Project	IEEE 802.16 Broadband Wireless Access Working Group < http://ieee802.org/16 >		
Title	clarification on the CX-Frame backward compatibility		
Date Submitted	2008-01-15		
Source(s)	Shulan Feng Hisilicon Tech. Co., LTD Bld.17, No.8, Dongbeiwang West Road, Hai-Dian District, Beijing, P. R. China	Voice: +86-10-82829151 Fax: +86-10-82829075 e-mail to : fengsl@hisilicon.com , fengsl@huawei.com	
Re:	IEEE 802.16 Working Group Letter Ballot #29		
Abstract	This contribution clarified the backward compatibility issue of CX-Frame and gives an example.		
Purpose	Accept.		
Notice	This document has been prepared to assist IEEE 802.16. It is offered as a basis for discussion and is not binding on the contributing individual(s) or organization(s). The material in this document is subject to change in form and content after further study. The contributor(s) reserve(s) the right to add, amend or withdraw material contained herein.

Clarification on the CX-Frame backward compatibility

Proposed Text

15.4.1.2 Scheduling of interference free intervals in the context of IEEE 802.16 MAC

[Figure hxx Map allocation for CX-frame](#)

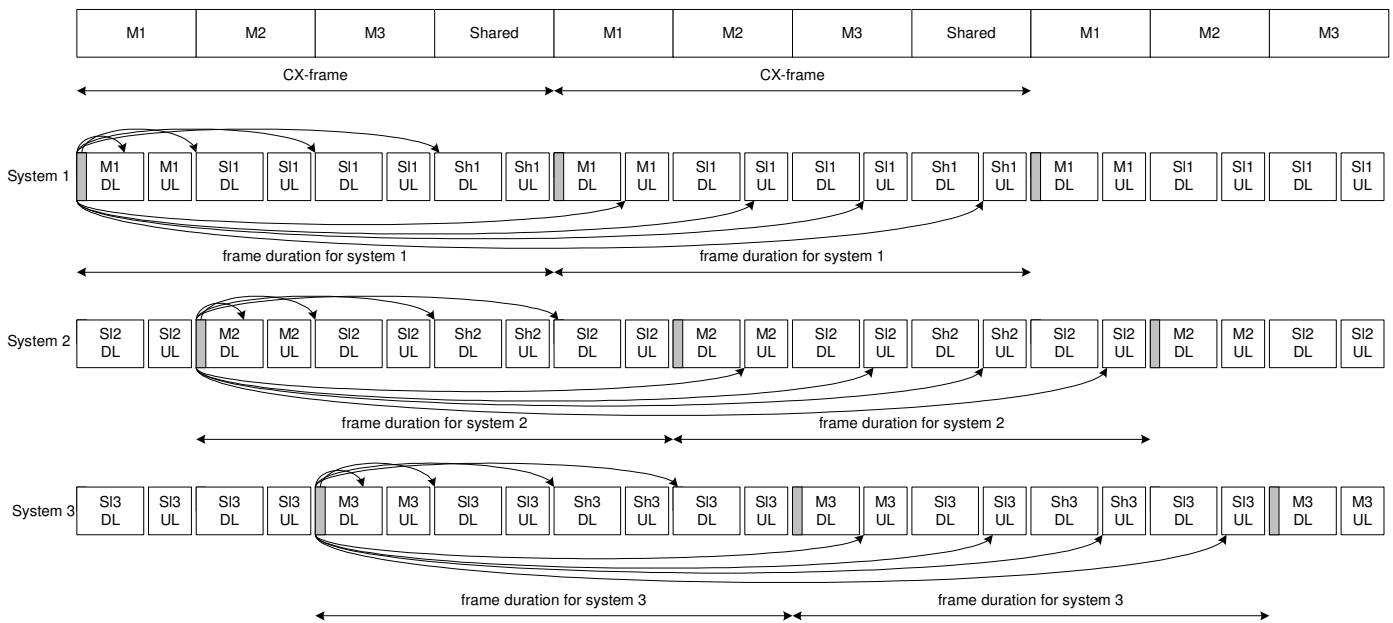
Comment 244 in comment database 80216h-07/053r2 questions that how the backward compatibility of CX-frame is supported is not clear.

It is stated "To enable SSs which do not support CX-Frame usage the resource allocation should be scheduled within each CX-frame in WirelessMAN-CX systems." It is not clear how the backward compatibility is supported.

In DL MAP message, allocate all the DL subframes and GAPS in all the CX-Frame time duration within one message, which use multiple DL MAP IE with GAP DIUC(13) to reserve all the time duration for GAP and UL subframe duration.

In UL MAP message, allocate all the UL subframes within the next CX-Frame time duration starting from the frame following the master allocation in one message, which use multiple UL MAP IE to indicate all the UL scheduling information within the CX-Frame.

To enable SSs which do not support CX-Frame usage, the resource allocation should be scheduled within each CX-frame in WirelessMAN-CX systems. The Preambles and MAPs should only be transmitted in the DL master sub-frames. The MAPs in master sub-frames shall be used to indicate the resource allocation of this system in a CX-Frame, possibly including the resource schedule in the master sub-frame, shared subframe, slave sub-frame, borrowed sub-frame, CXCBP sub-frame and optional common sub-frame. In DL MAP message, allocate all the DL subframes and GAPS in all the CX-Frame time duration within one message, which use multiple DL MAP IE with GAP DIUC(13) to reserve all the time duration for GAP and UL subframe duration. In UL MAP message, allocate all the UL subframes within the next CX-Frame time duration starting from the frame following the master allocation in one message, which use multiple UL MAP IE to indicate all the UL scheduling information within the CX-Frame. See figure hxx as an example.
